JORDAN VALLEY WATER TREATMENT PLANT
FILTER AND CHEMICAL FEED UPGRADES

JVWCD PROJECT #4289

ADDENDUM NO. 2
TO THE
CONTRACT DOCUMENTS

APRIL 2025

JORDAN VALLEY WATER TREATMENT PLANT
FILTER AND CHEMICAL FEED UPGRADES
ELECTRICAL
ENLARGED SITE PLAN 4

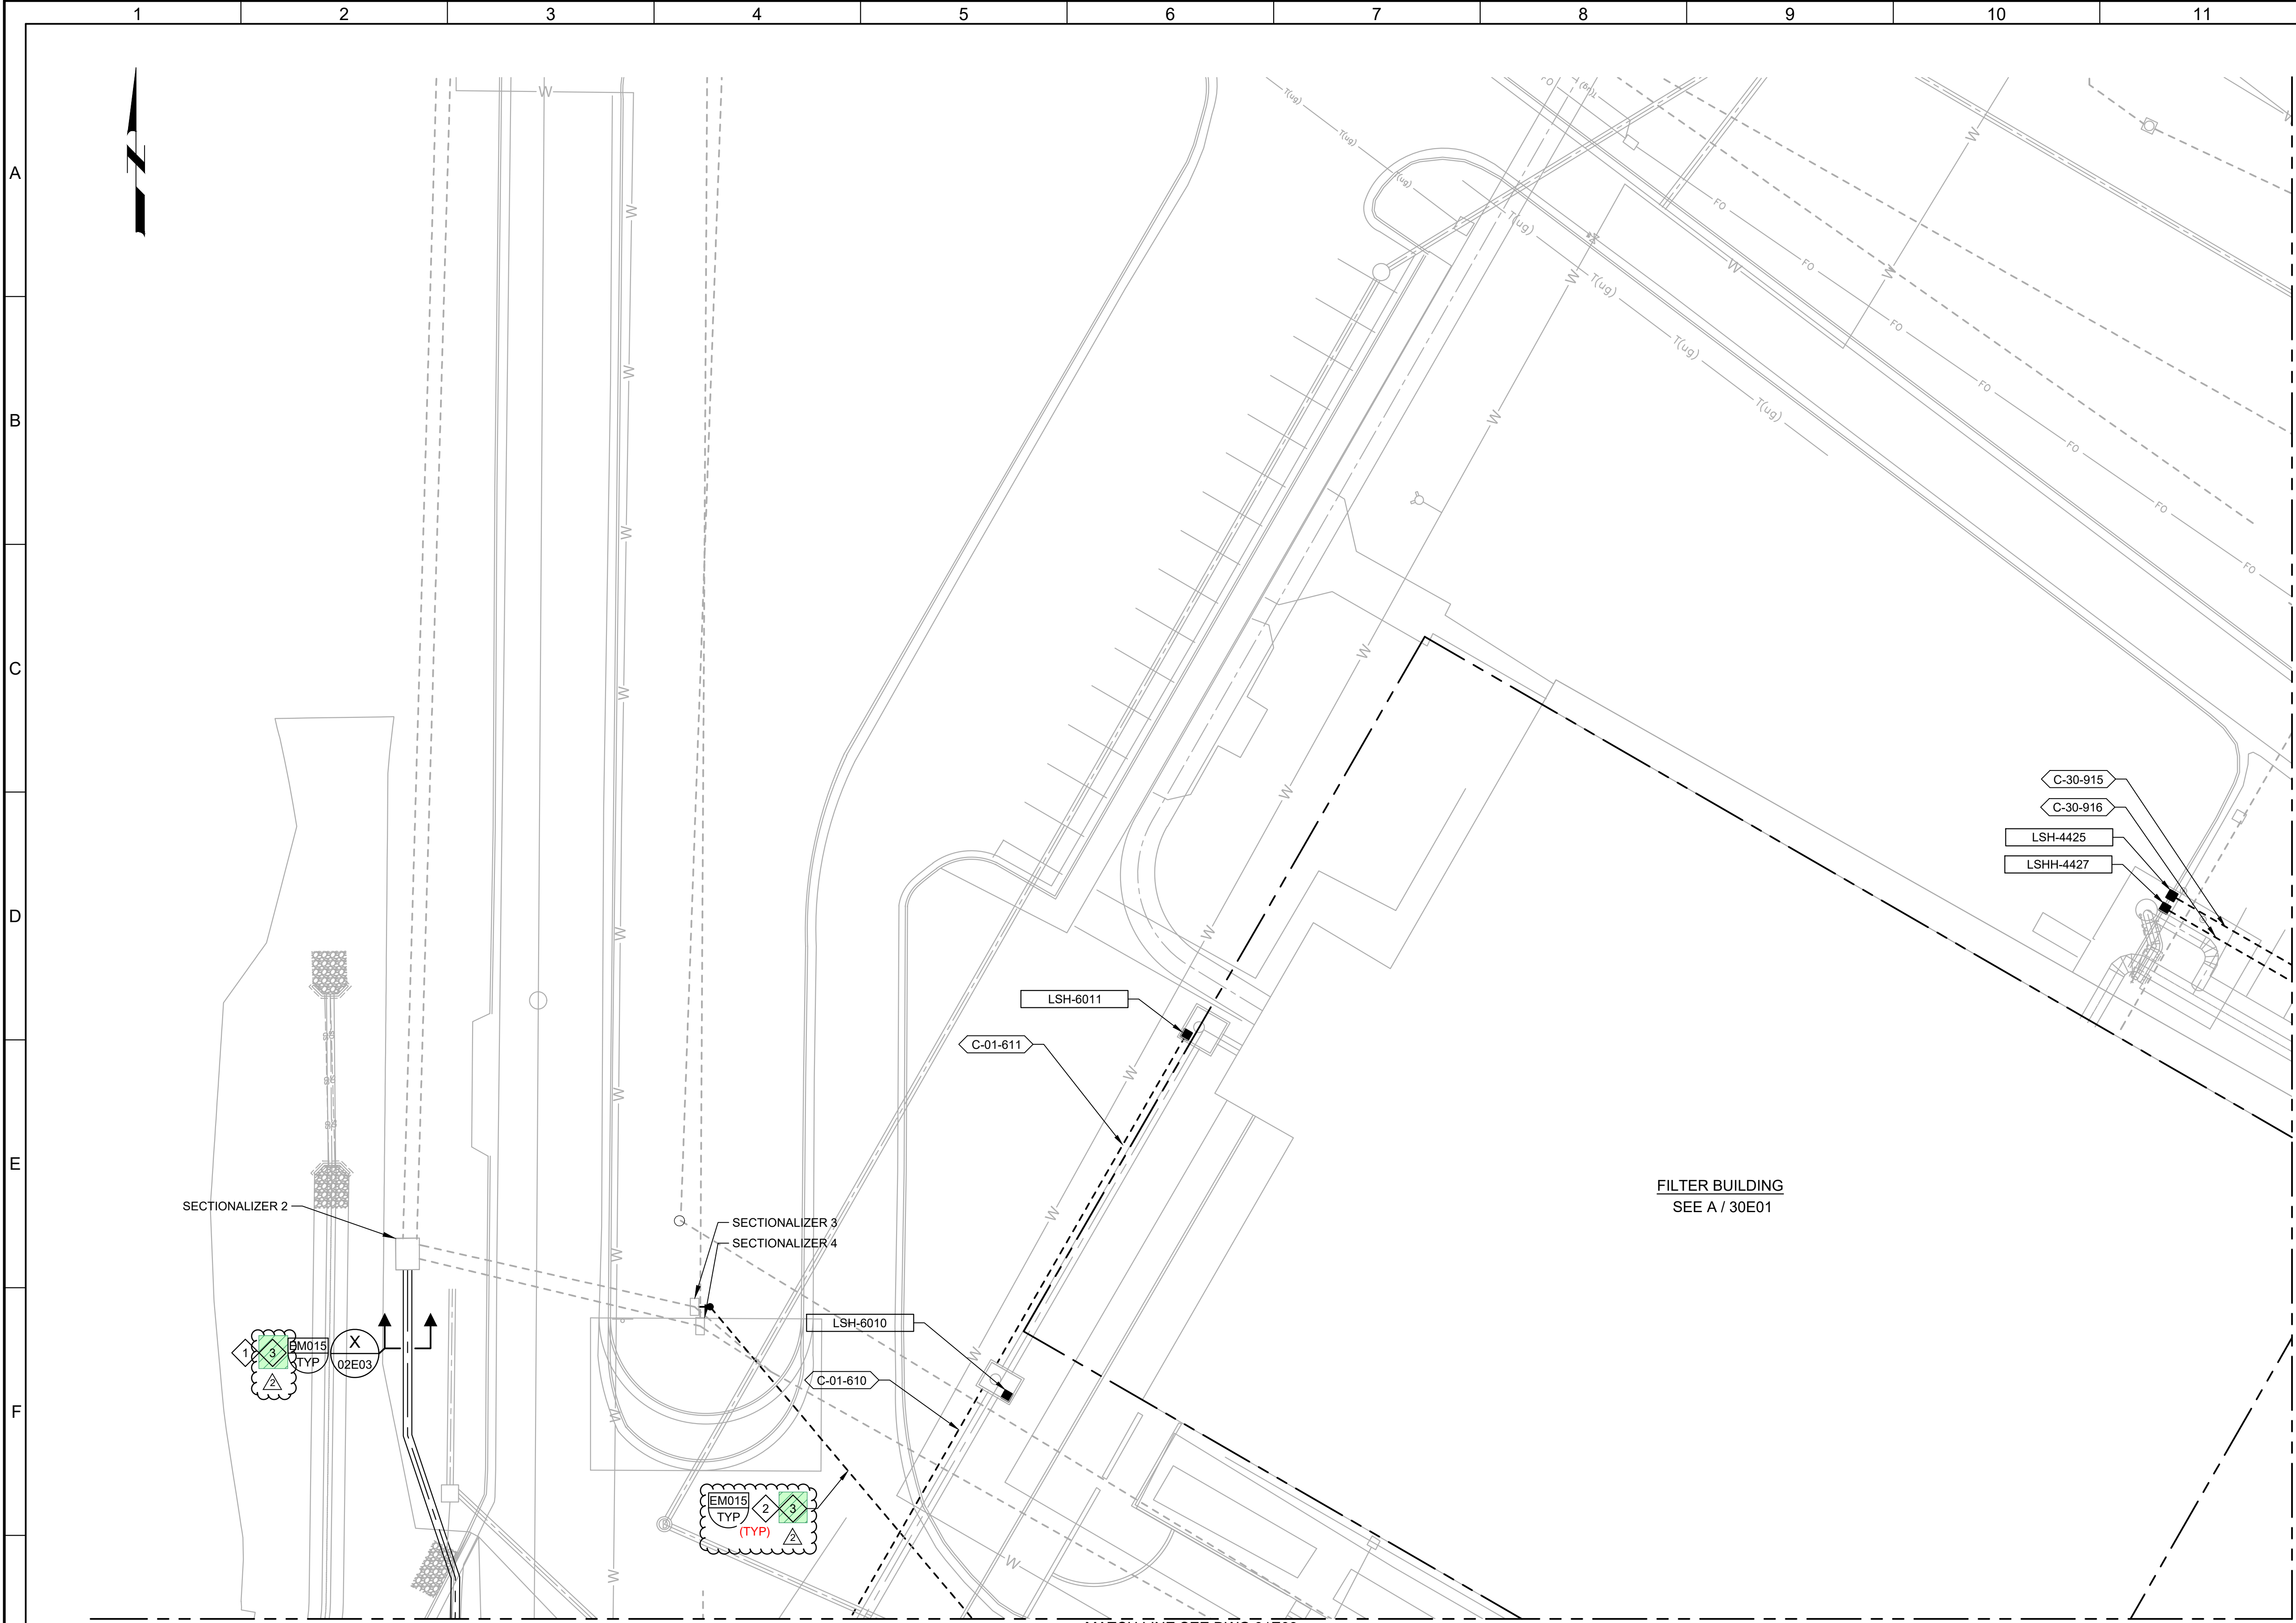
- REROUTE EXISTING 12.47KV SINGLE PHASE CIRCUIT BETWEEN HANDHOLE AND SECTIONALIZER 4 FOR THE CELL TOWER. REFER TO ONE-LINE DIAGRAM ON DRAWING 03E02 FOR CABLE SIZE. **SPlice IN HANDHOLE AND** PROVIDE NEW CABLES TO MATCH EXISTING CABLES.
- INSTALL 5-INCH PVC CONDUIT.
- PROVIDE CONCRETE CAP OVER DUCT BANK AS SHOWN IN THE TYPICAL DETAIL.**

INSTALL LOAD BREAK ELBOW TO CONNECT TO SECTIONALIZER.
